**MONTGOMERY COUNTY HISTORIC PRESERVATION COMMISSION**  
**STAFF REPORT**

<b>Address:</b>	9220 Damascus Hills Lane, Damascus	<b>Meeting Date:</b>	6/12/2024
<b>Resource:</b>	Master Plan Site #11/21 ( <i>Rezin Bowman Farm</i> )	<b>Report Date:</b>	6/5/2024
<b>Applicant:</b>	Daniel Ferenczy	<b>Public Notice:</b>	5/29/2024
<b>Review:</b>	HAWP	<b>Tax Credit:</b>	Partial
<b>Case Number:</b>	1071680 RETROACTIVE	<b>Staff:</b>	Chris Berger

**PROPOSAL:** After-the-fact fence installation, window alterations, door alterations, installation of new lighting and proposed window casing alteration and fenestration installation.

*Figure 5: The applicant provided this undated photo of the Milk House. Note the sliding door and what appears to be a wood sash window on the right-side elevation.*

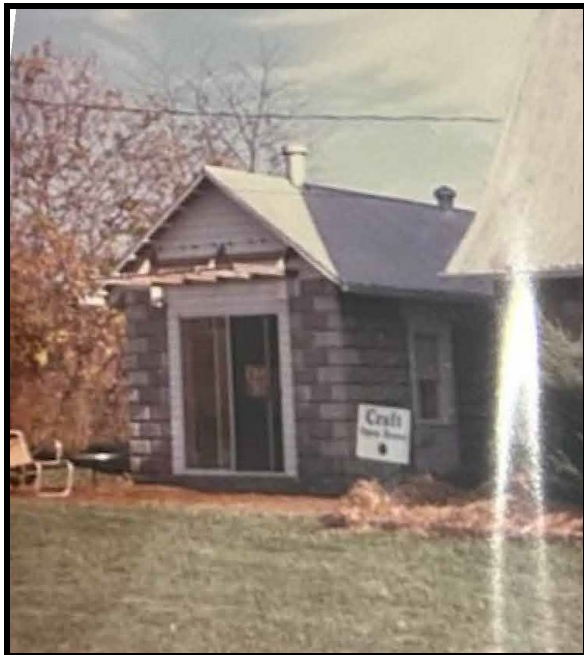
The applicant installed a composite sliding door on the front elevation (**Figure 12**). The Shaker Gliding 2/3 Lite door replaced the remnants of the double metal sliding doors on the front elevation. It is paneled with large, single lites on each of the doors. The archival photo from 1973 shown in **Figure 4** shows a window on the elevation. It is likely a sliding metal door was installed shortly thereafter when the building transitioned to a new use but prior to its historic designation in 2009.

*Figure 6: The applicant provided this photo that shows the fence in front of the Milk House.*

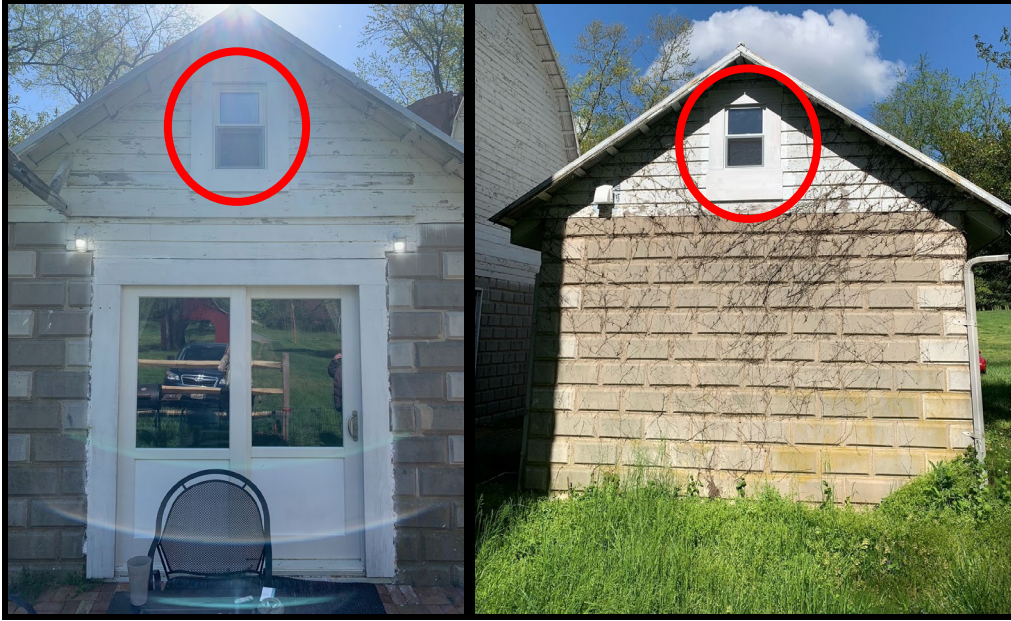
Staff supports the retroactive fence installation and recommends approval. The fence consists of two sections of untreated wood posts and rails standing approximately 4 feet tall and spanning about 25 feet (**Figure 6**). It delineates the boundary of the brick patio in front of the Milk House.

In accordance with Chapter 24A-8(b)(1), the fencing does not substantially alter the exterior features of the historic site. The work also meets Chapter 24A-8(b)(2) as the rustic fence is compatible in character and nature with the historical features of the former agricultural property. Further, in conformance with the applicable *Standards*, the historic character of the property has been retained and preserved by the fence's installation; its installation did not destroy historic materials that characterize a property; and if

*Figure 8: This photo of a traditional milk house shows a window in the gable end.  
Source: Frandsen, J. H. and Nevens, W. B., "Dairy Barn and Milk House Arrangement" (1919). Historical Circulars of the Nebraska Agricultural Experiment Station. 7. <https://digitalcommons.unl.edu/hcnaes/7>*

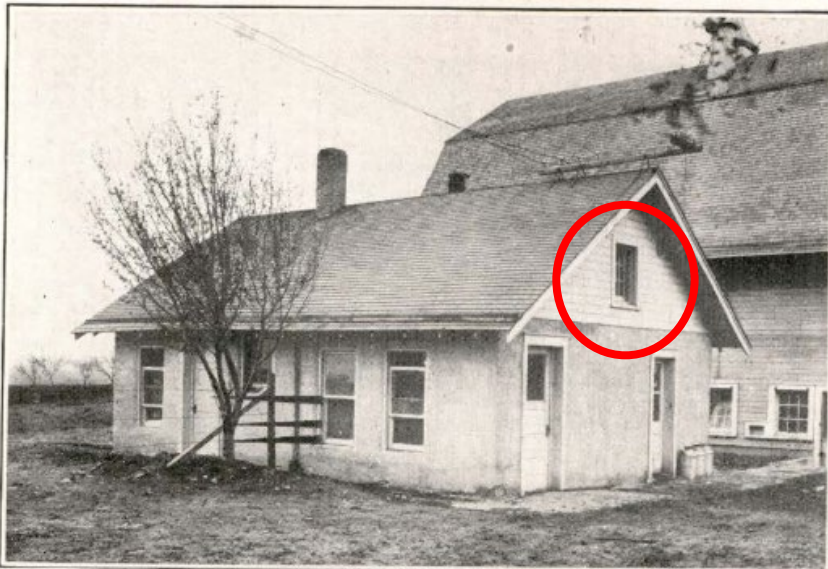
The applicant said he created the window openings and installed Anderson Fibrex windows measuring 18-by-24 inches in the gable ends to provide light and ventilation to the building (*Figure 7*). The openings are centered in the gable ends, just under the roofline. Staff does support the new openings and corresponding windows. Staff supports the material of the windows because they are new to the building and did not replace previously installed windows. The windows are appropriately sized for the building and were placed in the wood siding and not the historic masonry. The windows improve the functionality of the space as it is further adapted from its original, utilitarian use. Staff notes there is precedent for windows in gable ends in milk houses; a photo shows an early 20<sup>th</sup> century milk house, similar in design to Rezin Bowman's Milk House, with a small window in the gable end (*Figure 8*).

**Figure 9:** The applicant proposes to reduce the width of the casing around the new gable windows from 6.5 inches to 3 inches.

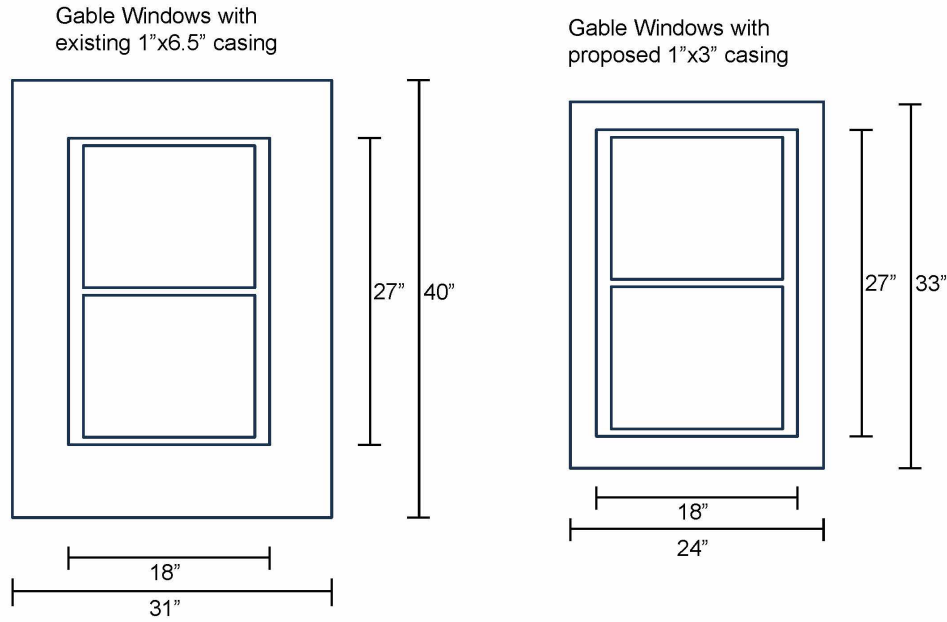
The HPC and staff did not support the prominent width of the casings installed around the new window openings, so the applicant revised the drawings to reduce the width from 6.5 inches to 3 inches (**Figure 9**).

Gable Windows with existing 1"x6.5" casing

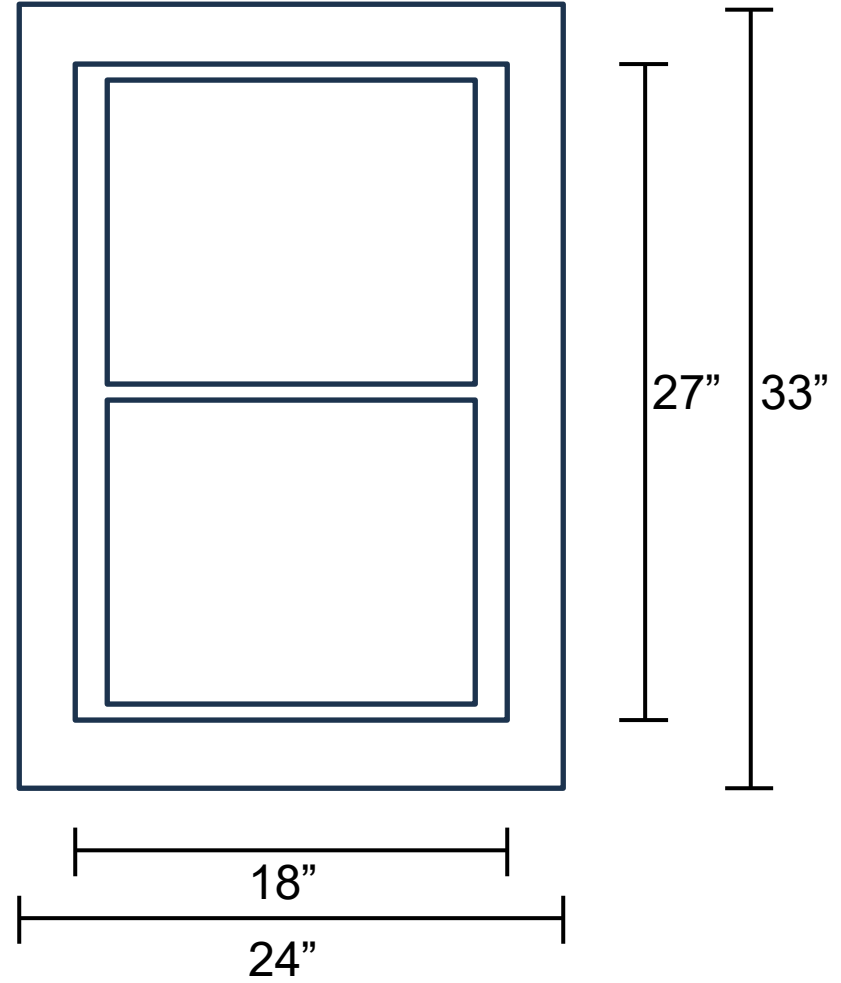
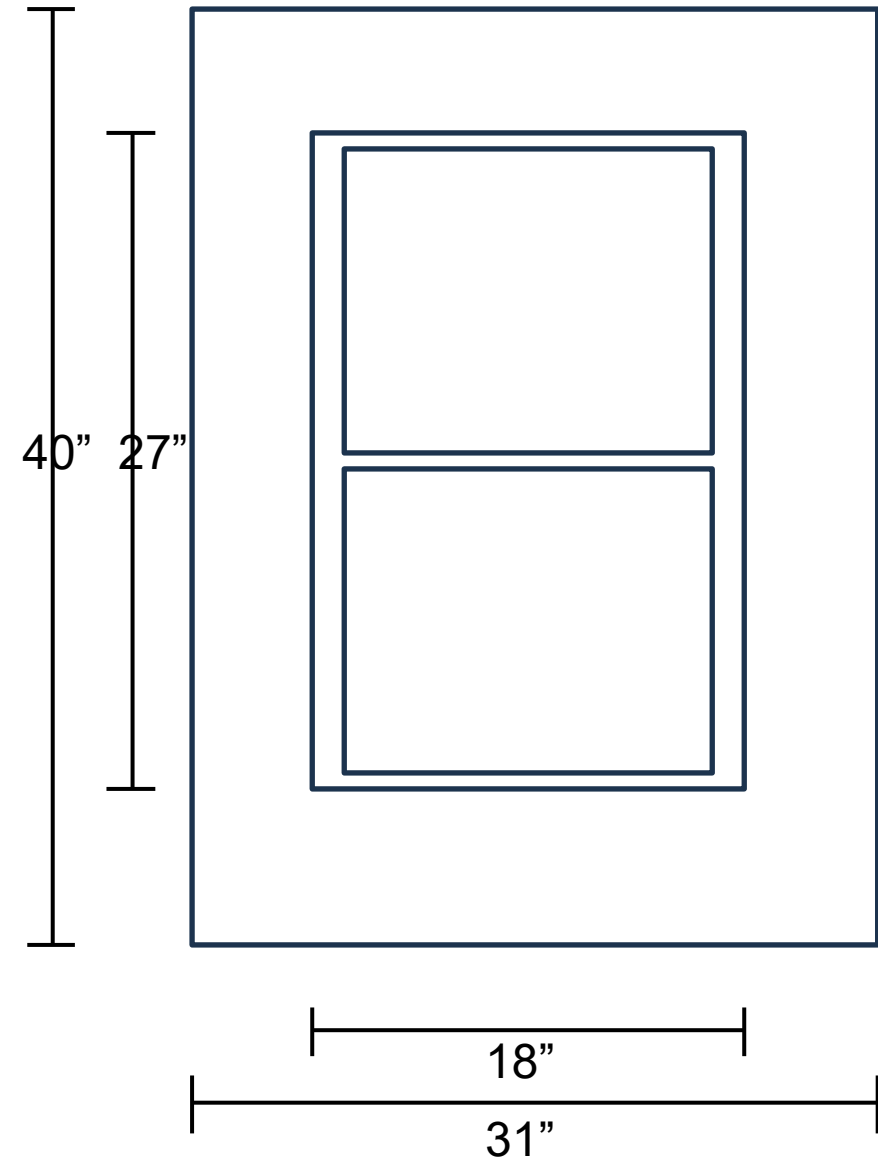
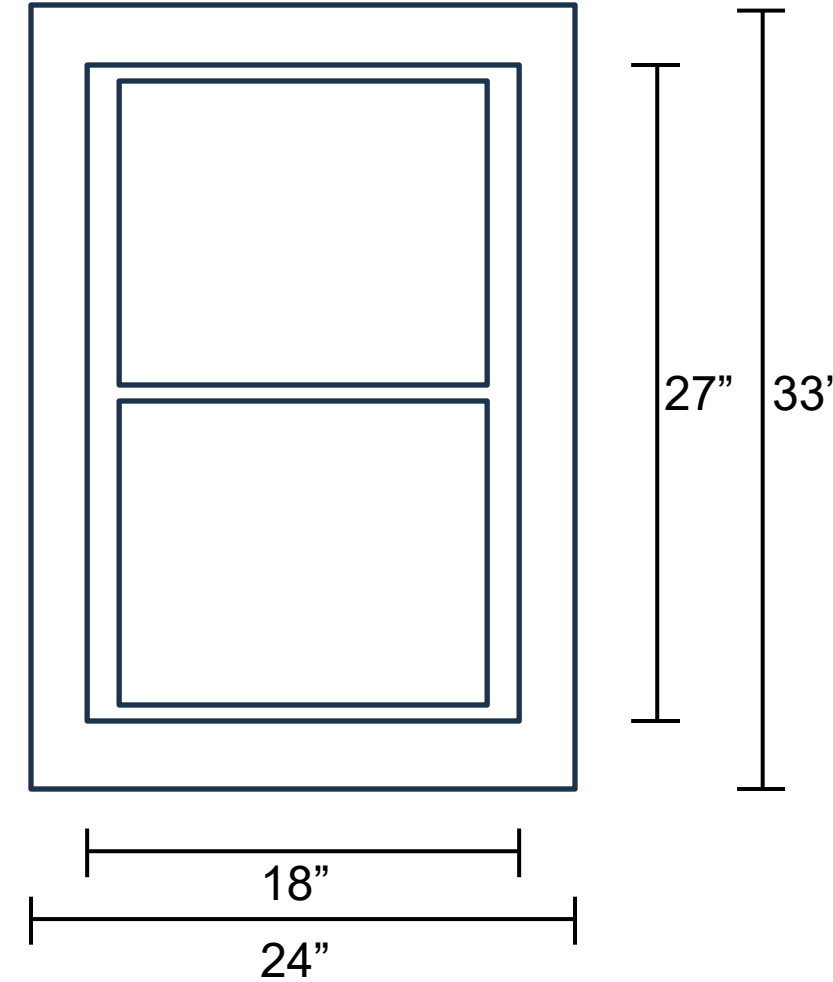
- Provide drawings with dimensions and materials labeled for the thinner window surrounds to be installed around each of the windows in the gable ends. Staff recommends the trim be approximately one to two inches wide.
- Architectural salvage companies may have matching sashes for the four windows, and staff will provide you with a list of area companies. EBay is another source for wood window sashes.
- Provide specifications for the replacement wood door on the right-side elevation.

Gable Windows with proposed 1"x3" casing

Replacement of one (1x) six over six lower wooden window sashes

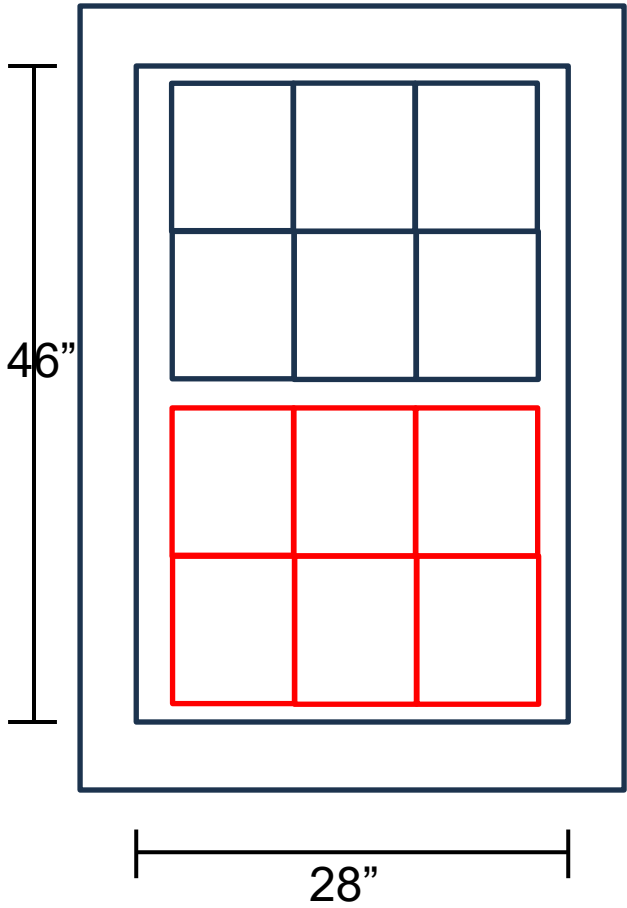
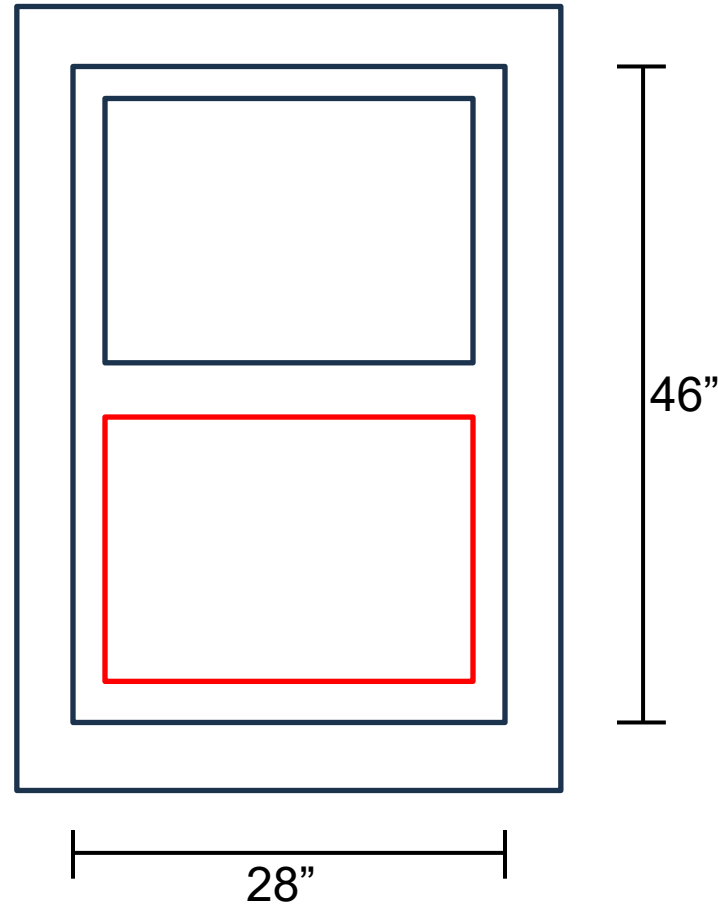
The applicant proposes to restore the bottom sashes on the four pre-existing windows. The applicant installed four new Andersen Fibrex 1/1 sash windows: two on the right-side elevation and two on the left-side elevation (**Figure 10**). According to the applicant, the wood sash windows were installed in the storm window track, and the composite windows were installed in preexisting metal window tracks. The wood upper sashes remain intact. The building originally had wood sash windows, and wood windows are present in **Figure 11**. The windows on the right-side elevation were later alterations that appear to have replaced doors in those openings, but based on the clapboard siding infill material present at the bottom of the openings the windows have been present for multiple decades and predate the historic designation. The window openings on the left-side elevation appear to date to the building’s construction, as evidenced by the wood lintels on top of each opening.

- The majority of commissioners said a wood lower sash should be installed at each of the four windows. The composite windows could then remain so long as they were completely located on the interior and the entire exterior window was wood.
- The existing sliding door on the front elevation is appropriate and should be allowed to remain.
- The majority of commissioners favored replacement of the fiberglass egress door with a door that was stylistically similar to the sliding door.
- The window openings in the gable ends can remain.
- The trim should be reduced in width.
- The replacement lights can remain.
- The fence was compatible to the building.

Replacement of three (3x) single pane lower wooden window sashes

Figure 15: The applicant provided this circa 2021 photo of the Milk House and Dairy Barn. The arrow points to what appears to be a wood screened door that may have been installed on the Milk House or Dairy Barn.

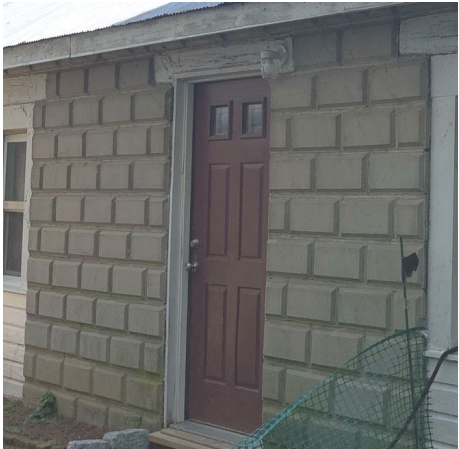
The HPC and staff did not support the installation of the fiberglass egress door on the right-side elevation, and the HPC recommended the applicant install a door that was stylistically similar to the sliding door. Staff recommended the applicant either install the door shown laying against the Dairy Barn in a 2021 photo or a similar design (**Figure 13**). The door could have dated to the 1930s and may have originally been installed on the Milk House or Dairy Barn. The applicant has provided two examples of wood doors: A two-paneled door with a single lite above and a three paneled door with six lites (**Figure 14**). Staff supports either example but recommends a condition that staff review and approve the final door design before installation.

Red side door to be replaced with older wooden door (representative examples below)
